IN THE MATTER of the Resource Management Act 1991 ('the Act')
AND
IN THE MATTER Of Resource Consent Application RMA/2020/2852 for the
Canterbury Museum Trust Board for a comprehensive
redevelopment of the Canterbury Museum complex including the
Robert McDougall Gallery

**EVIDENCE OF TREVOR WATT OF ATHFIELD ARCHITECTS LIMITED ON BEHALF OF THE
CANTERBURY MUSEUM TRUST BOARD**

Dated 25th May 2021

Image 5: Proposed 1958 / 1877 Wall Junction

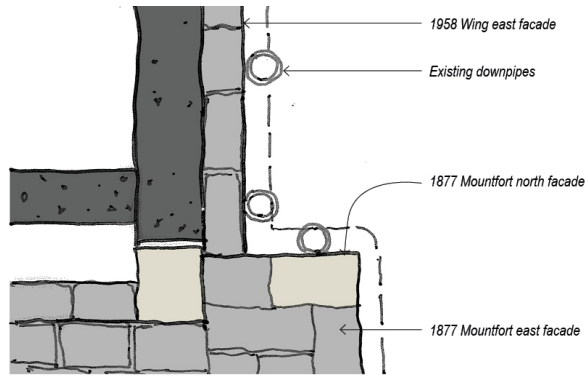
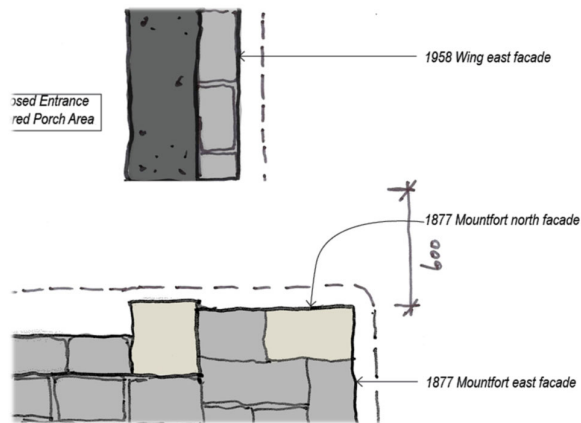
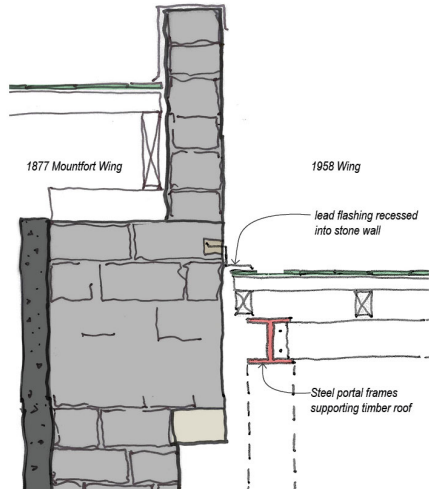
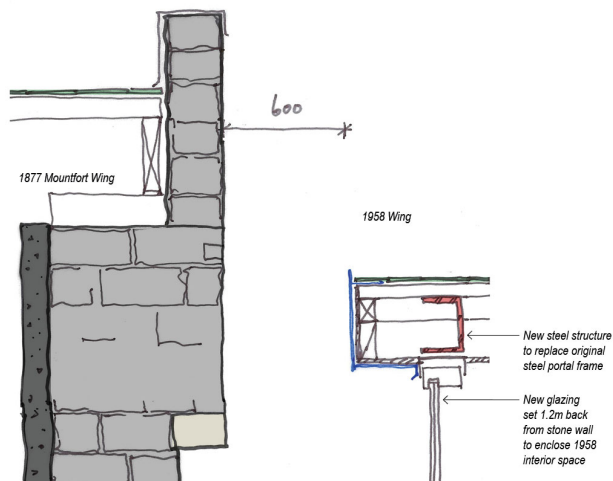
79 The only area of disagreement regarding proposed changes to this building relate to the so-called 'slice' to the listed 1958 stone veneer façade to provide a separation to the 1877 Wing.

84 Clause 164 *'In my opinion the benefits of the external exposure of the north wall of the 1877 wing do not outweigh the removal of part of the Centennial Wing Façade, and the disruption of the continuous façade presented to Rolleston Avenue. This change inserts a bold 21st century conservation solution for additions, which*

visually and physically interrupts the continuity of the principal stone Gothic façade of the complex. This change will reduce the integrity of the heritage item and also the Museum complex as a whole...'

Refer images 3 to 8 for sketches of these methodology options at both roof and wall junctions. It is clear which detail has the least intervention to heritage fabric and provides the best legibility between heritage items of differing periods. Images 4 and 7 shows options for proprietary seismic joint systems.

92 **The proposed separation detail with no infill is absolutely the least intrusion and impact on the heritage fabric of the highly significant 1877 façade and allows the total highly significant façade to be revealed in full.** This is achieved with the minimal removal of heritage fabric of secondary significance.

- 93 This 600mm wall and roof separation is completely open (Athfield Architects Concept Design Report, pages 143 to 145 are useful drawings which highlight the nature of this junction, including extent of unveiling of the 1877 north wall, extent of 1958 building removal and the line of the new glazed wall. I note there are numerous references in the evidence of Ms Lutz and the CCC Senior Planner report that this is a glazed separation, but this is not correct. In my opinion, an assessment of a glazed separation would be different to an assessment of a completely open separation.
